Block/s:	15	Agenda Item:	Significant community concern
Section:	37	Date:	14/12/2021
Suburb:	Griffith	DA Number:	202139308
Zone:	RZ1	Address:	18 Lockyer St
Representations:	40	Assessment officer:	Matthew Forman
Cleared by:	Richard		
Proposal:	PROPOSAL FOR MULTI UNIT DEVELOPMENT - demolition of the existing dwelling and the construction of three single storey dwellings with attached garages, driveways, landscaping and associated works, lease variation to permit supportive housing and to remove the maximum number of dwellings permitted on the block		
Reason for seeking advice:	30 or more representations		
Additional members required:	N/A

PROPOSAL FOR MULTI UNIT DEVELOPMENT - demolition of the existing dwelling and the construction of three single storey dwellings with attached garages, driveways, landscaping and associated works, lease variation to permit supportive housing and to remove the maximum number of dwellings permitted on the block

An assessment of your development application (DA) has been undertaken and in order to progress the assessment of your DA (DA 202139308 over Block 15 Section 37 Griffith), please provide further information in response to the following matters:

Image 1

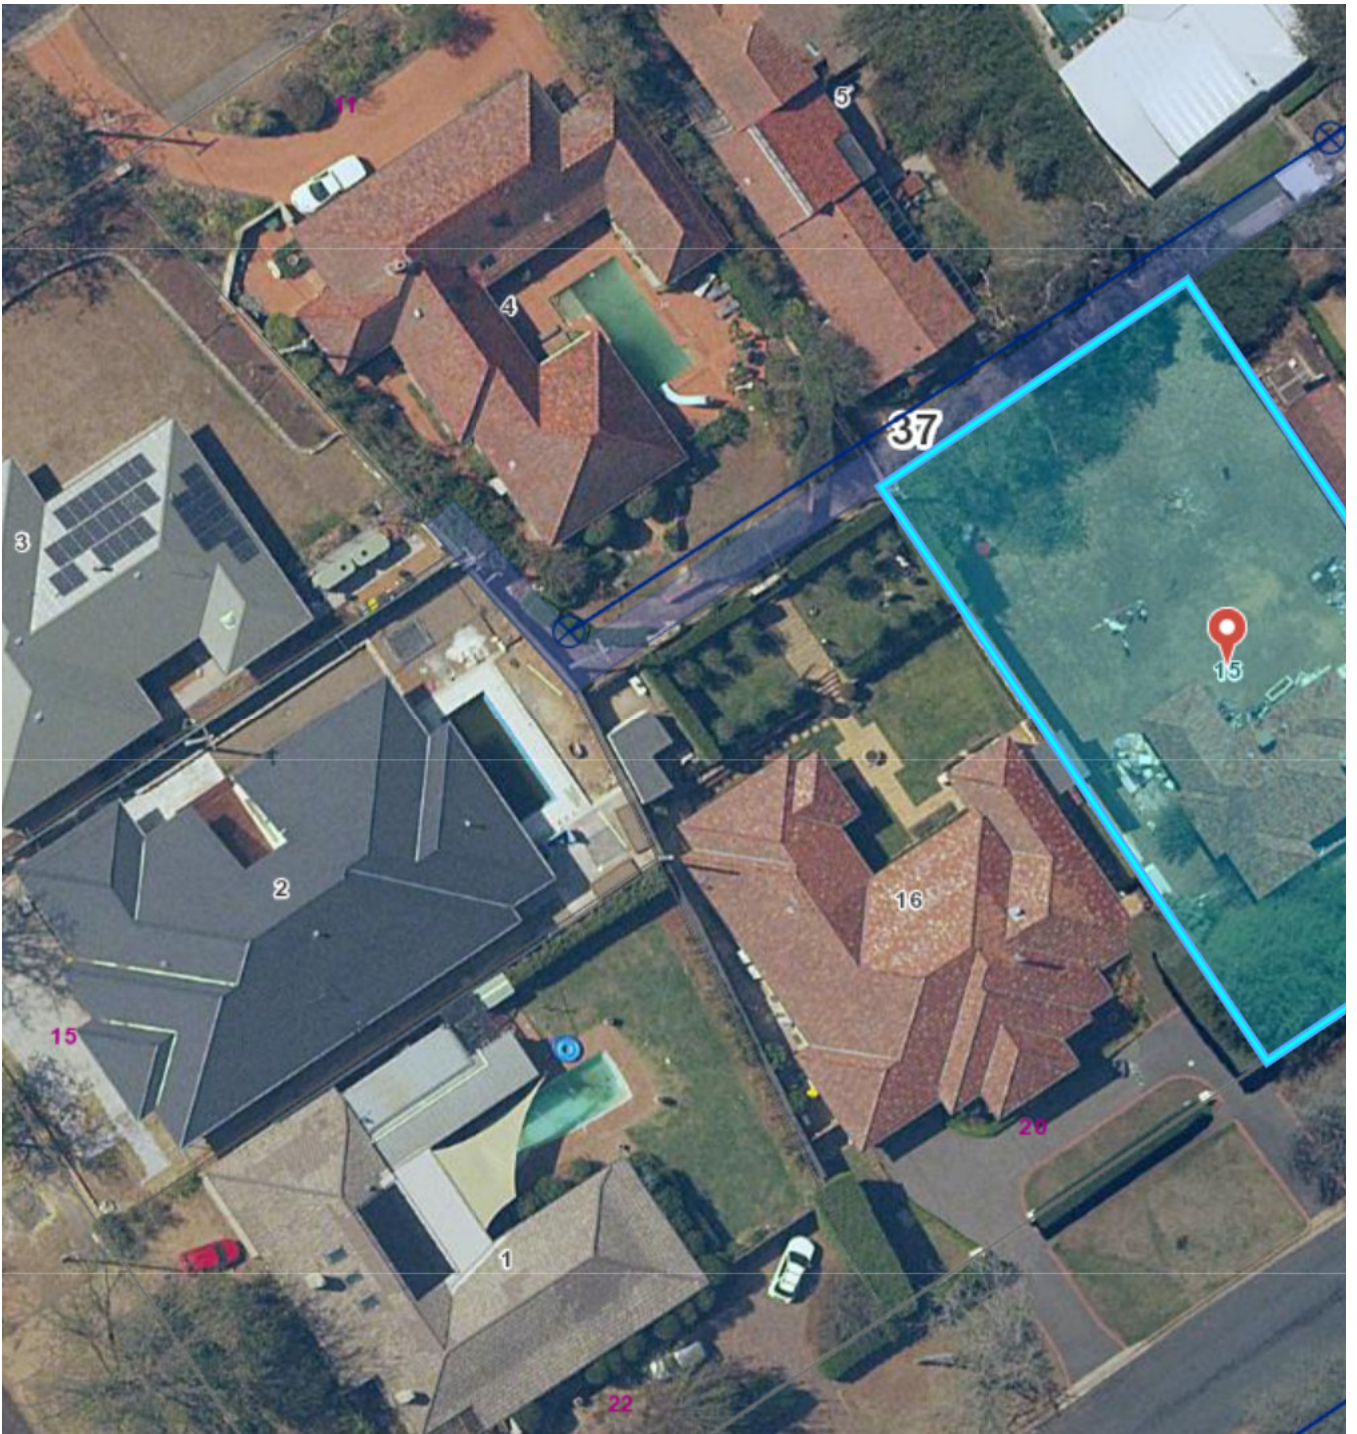
2. The proposed drainage to the kerb is NOT supported and all stormwater must drain to the SW network through a new SW tie either to the SW network behind the this block or to the front across the road as shown in Image 1 below:

3. If the stormwater tie is to be connected to the SW network across the road then the alignment must not impact on the existing street tree.
